To: Dan Fisk, Paramounte Engineering
From: Brian Chambers, Senior Planner; 910.342.2782
CC: File;
Date: 2/16/2021
Re: Wilmington Three Phase A TRC Rev 1

Engineering has reviewed the plans for the Wilmington Three Phase A project submitted January 13, 2021 for TRC review and have the following comments:

Project Name: **Wilmington Three Phase A**

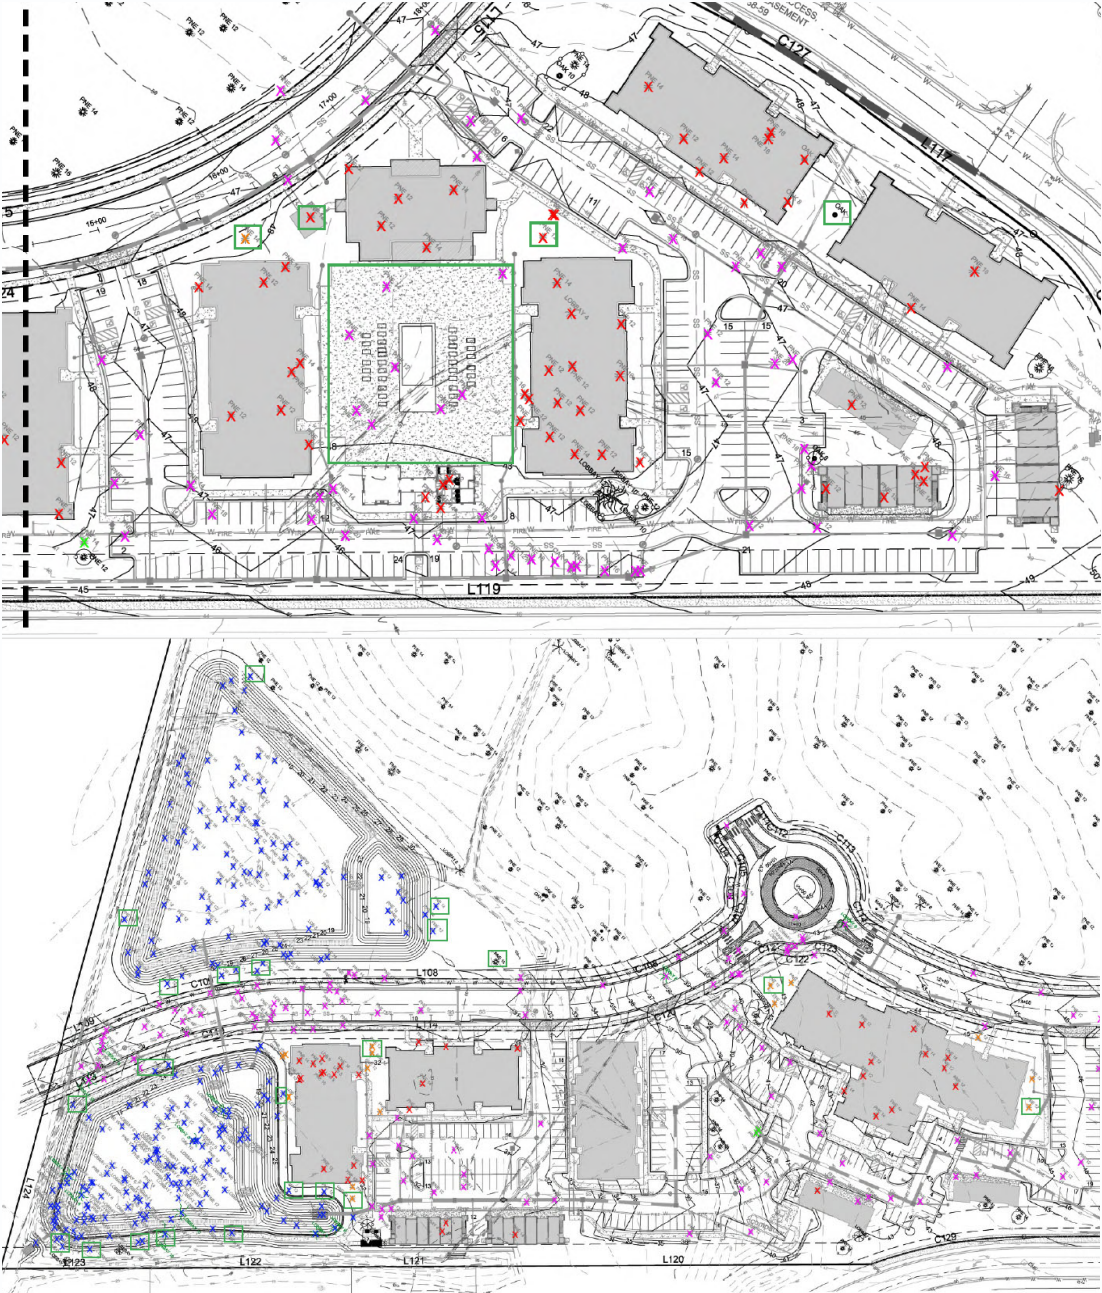
- Show tree protection fencing around critical root zone for trees being retained. CRZ is 1 foot radius for every 1 inch DBH.
- What is small building next to club house? Can it be relocated to avoid protected tree?
- See highlighted areas below (green boxes). These areas correspond to notes and/or identify trees that need justification for removal.
